Design Revision 02

Building: Naval Station Norfolk, VA Waterfront

Project Title: FY25 / FY26 Maintenance Dredging @ Naval Station, Norfolk

Date: 13 August 2025

NAVAL BASE NORFOLK PIER 11 PROJECT NORFOLK, VA		2512.250623.POST	
POSTCONSTRUCTION SURVEY DEBRIS CONTACTS		1" = 20'	
JULY 8, 2025		DM	
DATE		DRAWN BY	
SHEET		DRAWING NO	
1 OF 3		001

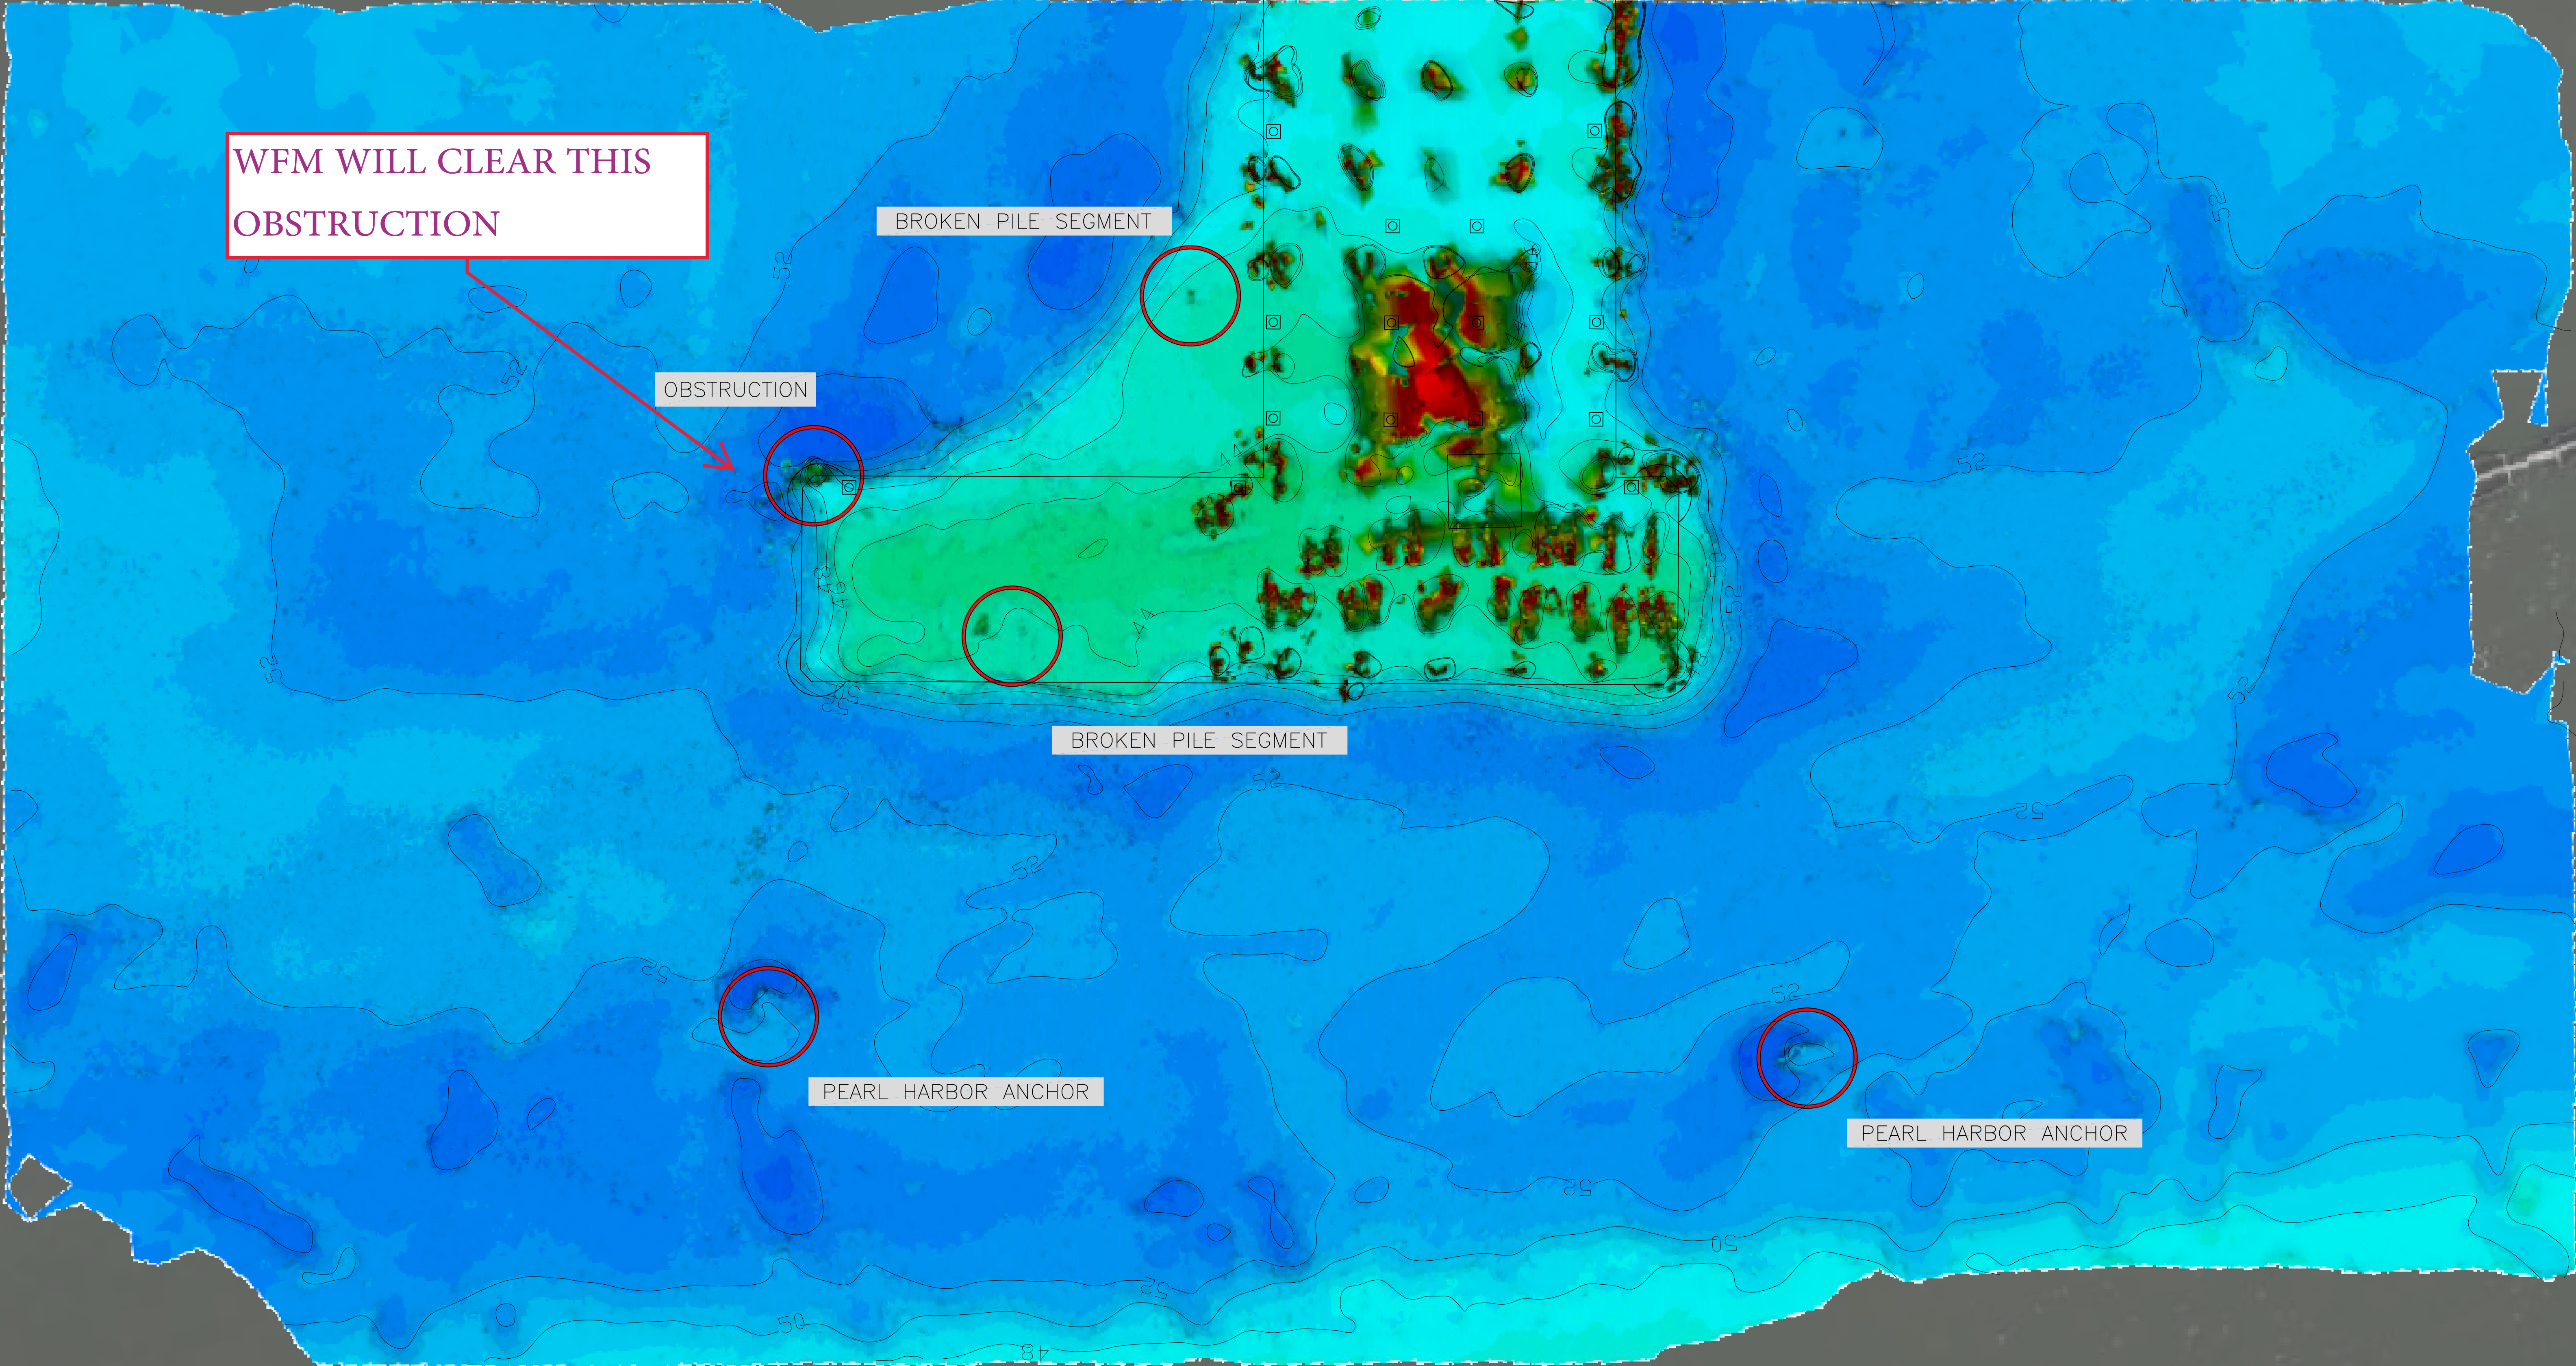
Approved as noted. Ensure obstruction is removed/demolished as noted in survey.
